FIGURE 18
Design Criteria for Anchored Bulkhead (Free Earth Support)

FIGURE 21
 Example of Analysis of Anchored Bulkhead

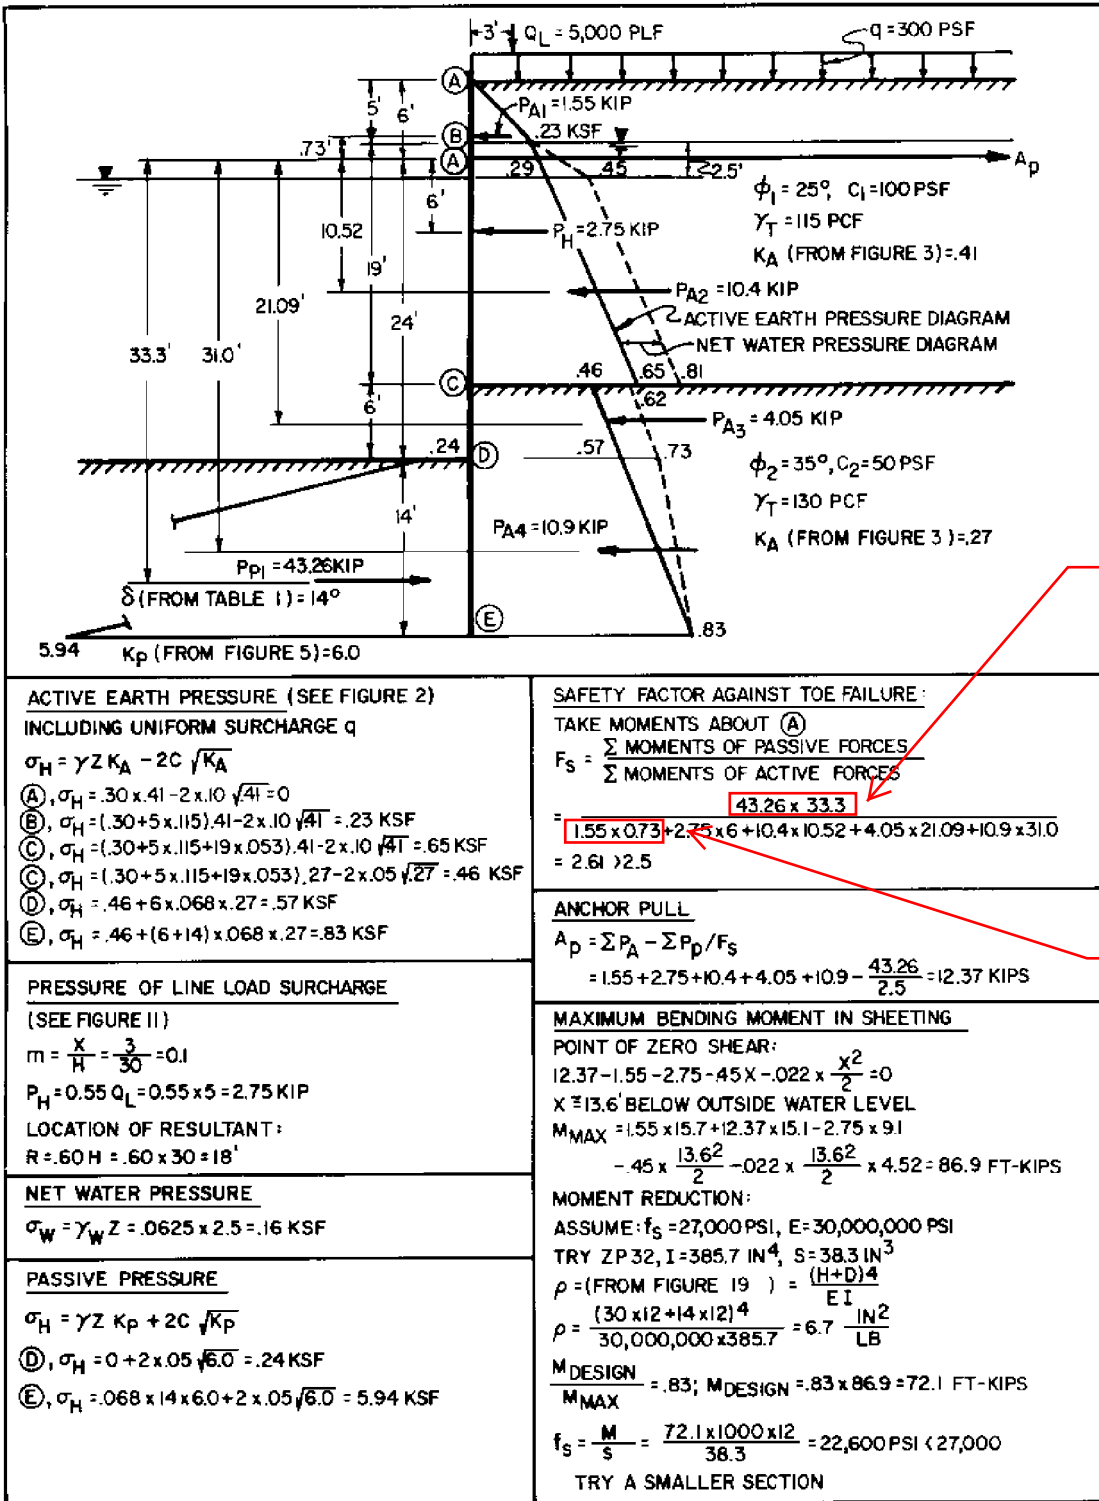
example in pag. 7.2-93 does not considers PP/FS when computing moments about a

example in pag. 7.2-93 does considers/ this approach for computing AP

No PP/FS/? as suggested in Pag 7.2-88

shouldn't this term be negative?
